SIB 51 06 25

RECALL 25V-106: REPLACE DOOR LATCH ON BOTH REAR DOORS

This Service Information Bulletin (Revision 2) replaces SI B51 06 25 **dated February 2025**.

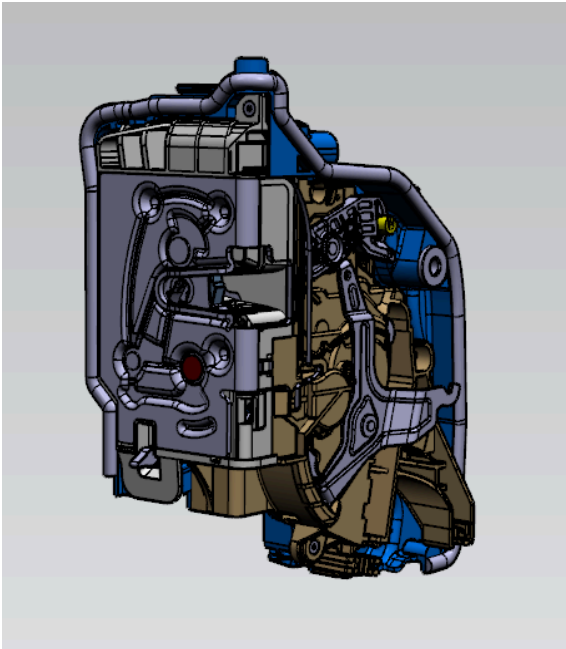
The rear door latch (illustration) systems on both rear doors may not meet a federal requirement. Specifically, instead of two actions to unlock and unlatch the door, only one action may be needed.

The current rear door latches on both doors do not comply with legal regulations.

Replace both (left and right) rear door latches.

1. Replace both (left and right) rear door latches following the repair instructions listed in ISTA/AIR 51 22 090.
